**73, 77 & 83 Linton Street, Kangaroo Point
QLD 4169**

Request to Change a Development Approval under s81 of the Planning Act 2016:
Development Permit for a Material Change of Use & Building Work – Multiple
Dwellings (Council Reference: A006350800)

Minor Change Application

Figure 3 Comparison of Ground Level Landscaping
Source: Excerpt from amended Landscape Concept Plans attached under Appendix B

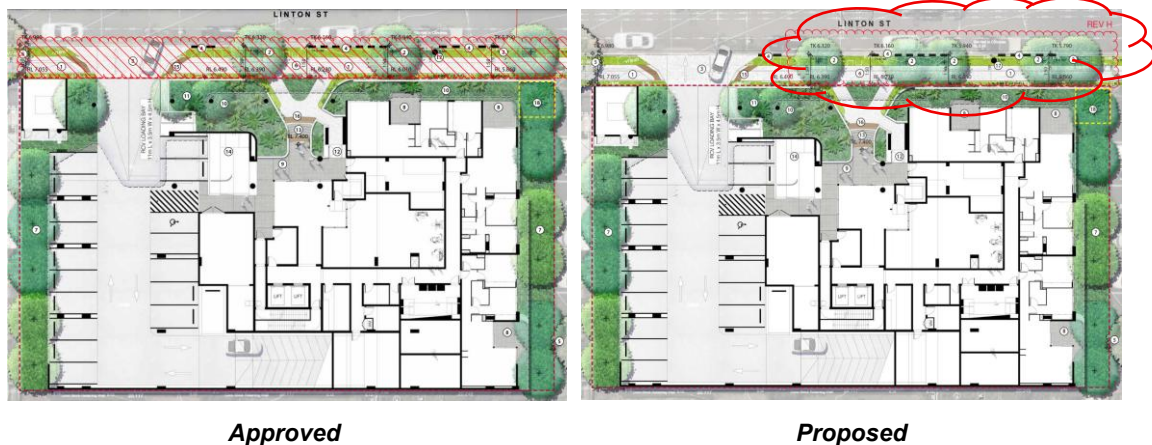
Deep planting and landscaping throughout the development is generally maintained in accordance with the current approval. However, it is proposed to modify the street tree arrangement as illustrated on the updated Landscape Concept Plan attached under **Appendix B**.

The revised street tree arrangement includes two (2) additional street trees, bringing the total tree count to five (5) trees along the Linton Street frontage (**Figure 3**). The addition of these trees results in an increase in the canopy extent and shade coverage across the site frontage, improving amenity for pedestrians and contributing to urban heat island mitigation. The increased tree count represents an improvement on the previous design and demonstrates the development's commitment to enhancing the public domain and green infrastructure outcomes for the site.

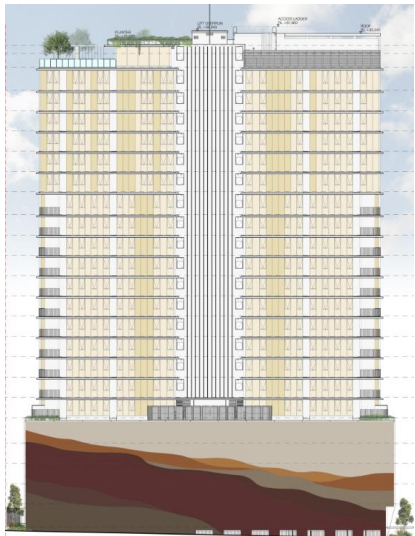
The minor change application retains the approved building height of 23 storeys. The proposal includes subtle adjustments to the tower, involving slight modifications to floor levels, which are generally marginally lower than the approved levels.

The lift overrun is proposed to decrease from RL 81.00m AHD to RL 80.74m AHD, while the roof access ladder is shown at RL 81.4m AHD. This element was not depicted in the current stamped approved plans with the highest component being the lift overrun. The proposed roof access ladder is a minor structure that does not impact on the appearance of building height.

Figure 4 Floor Layout of Dual Occupancy on 77 Linton Street

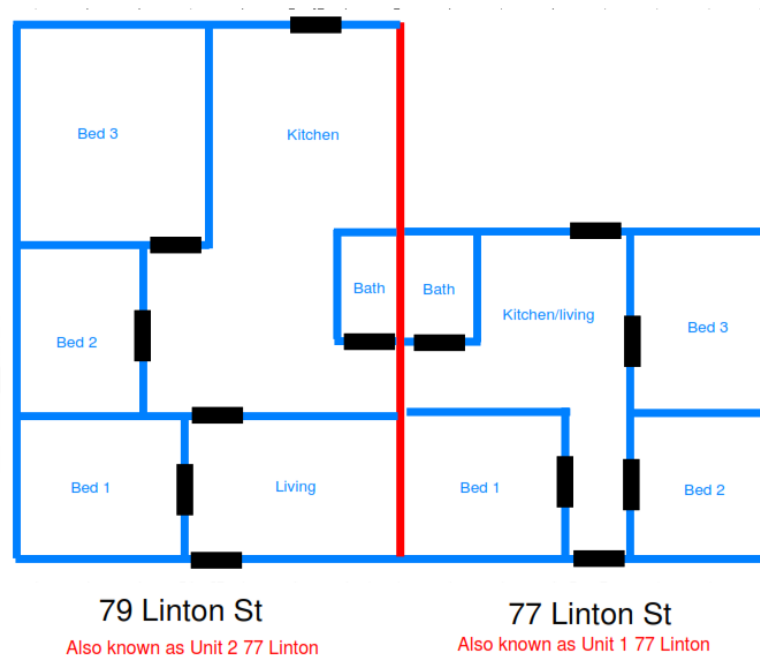
- Removal of one x 2-bedroom dwelling unit on the ground level from the demand calculation;
- Correction of the credits applied for the Dual Occupancy on 77 Linton Street. Both dwellings part of the Dual Occupancy are 3-bedrooms as illustrated in **Figure 4** below. We also have videos of each dwelling which can be provided to Council to confirm the floor layouts.
